RFP 2015-0028 - ADDENDUM 1

SHELTER COVE TO PALMETTO DUNES PEDESTRIAN UNDERPASS BRIDGE REPLACEMENT Town of Hilton Head Island, South Carolina

Date Issued: November 19, 2015

1 OVERALL SITE PLAN
 C105 SCALE: 1" = 20'-0"

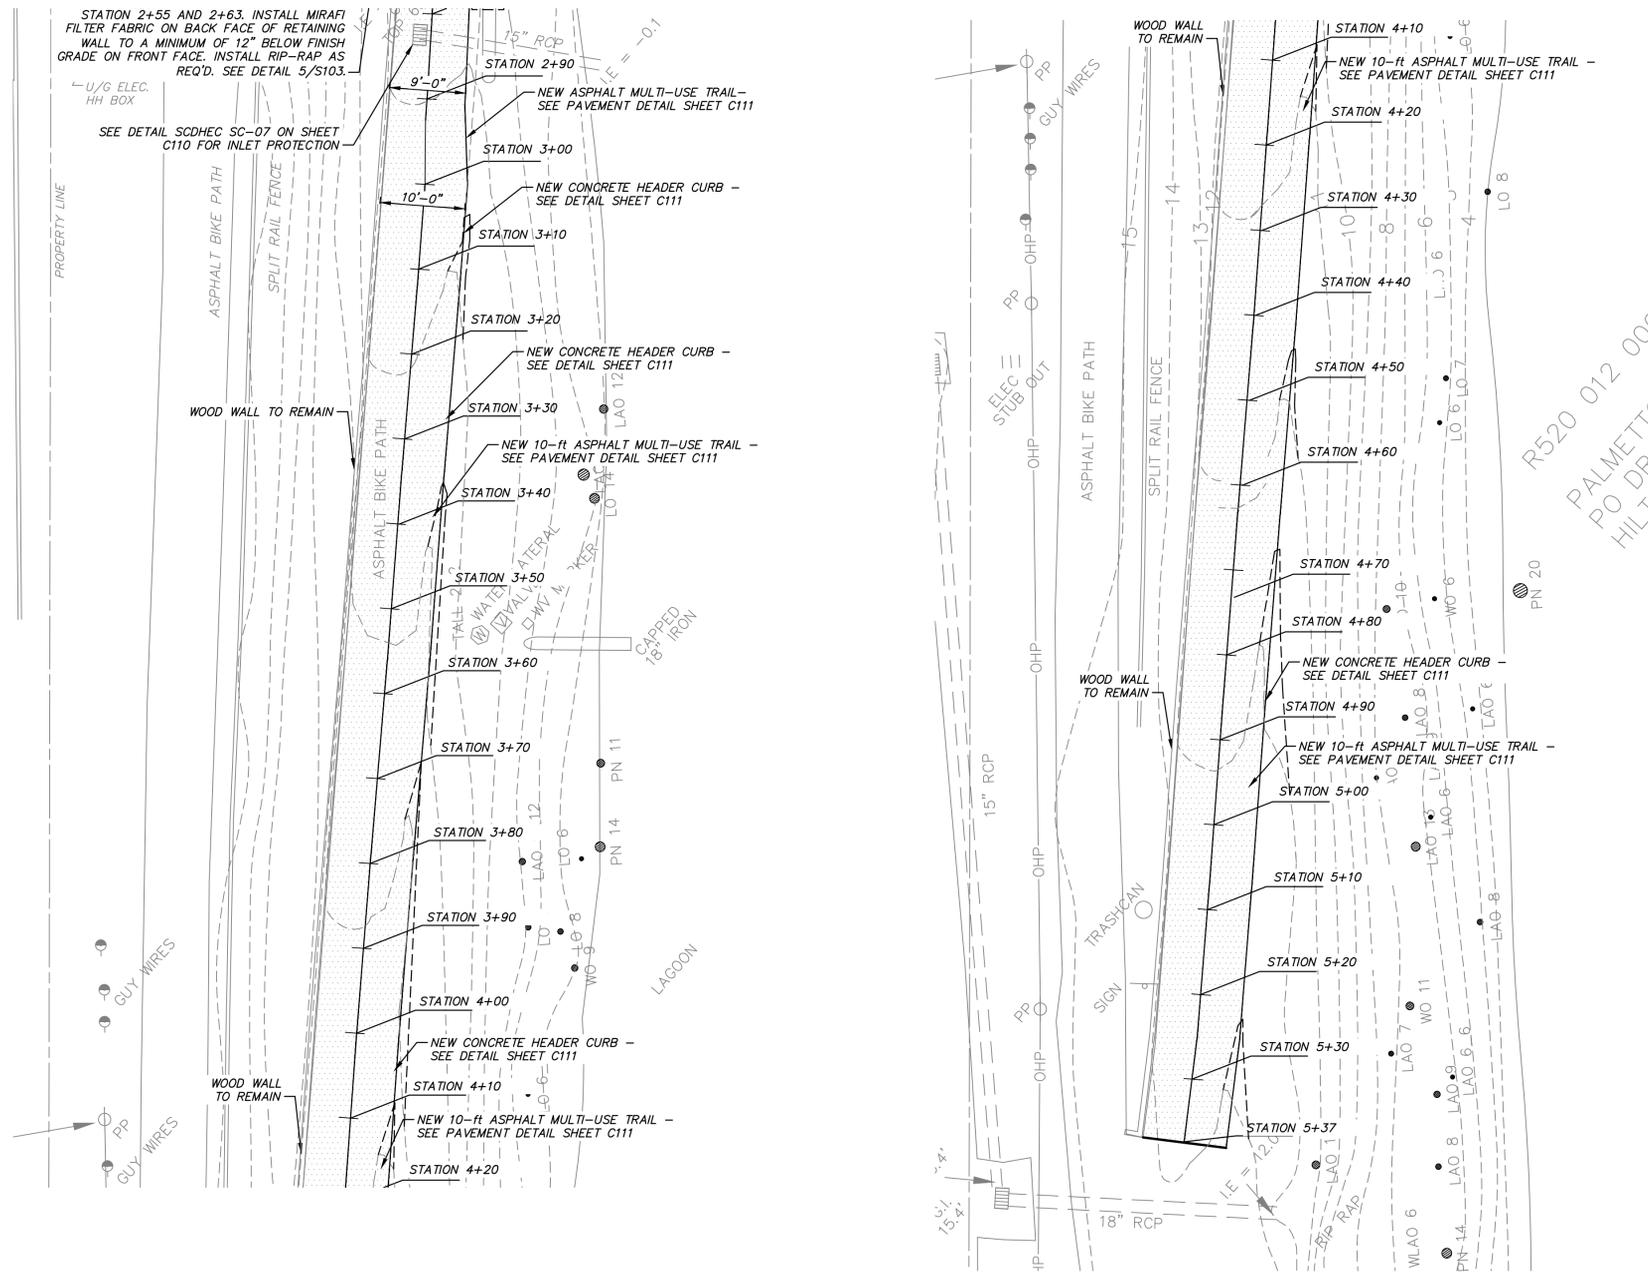
Q4. Drawing C105 lists the extent of the project at Station 0+00. West of this station, do the end timber retaining walls need adjustment to the new path width and the sidewalk removed, widened and replaced for concrete end abutment construction?

A4. Yes, the new retaining wall on the north side of the concrete path shall be retained. The older wall on the south side of the concrete path shall be removed and disposed of, and the concrete pathway widened to 10.0 feet (Sta. 0+00 to the intersection). The shoulder on the south side of the widened concrete path shall be graded to tie in at no steeper than 1:1 slope. The graded area shall be stabilized by mulch or grass. The Town shall be responsible for any landscaping.

2 BRACKET DETAIL
 S102 SCALE: NOT TO SCALE

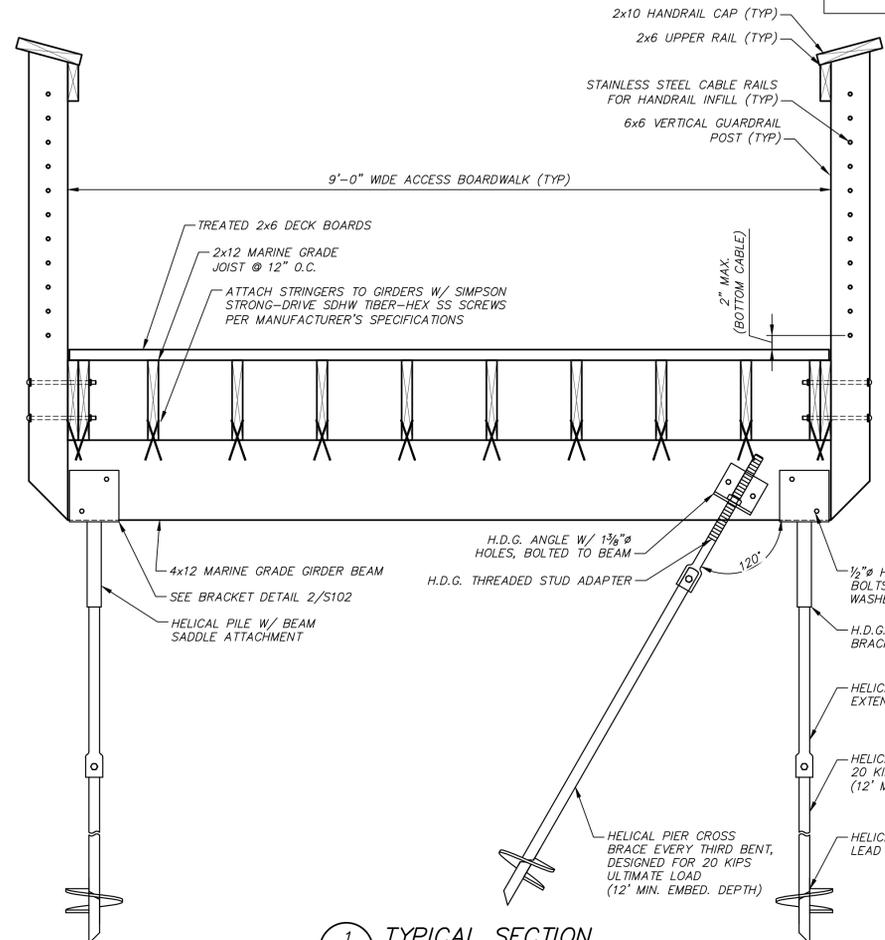
Q15. Will the galvanized bent brackets need to be bolted to the pile shaft - plan shows no detail on this?

A15. See revised detail 2/S102 as part of Addendum 1 plans dated 11/17/2015.
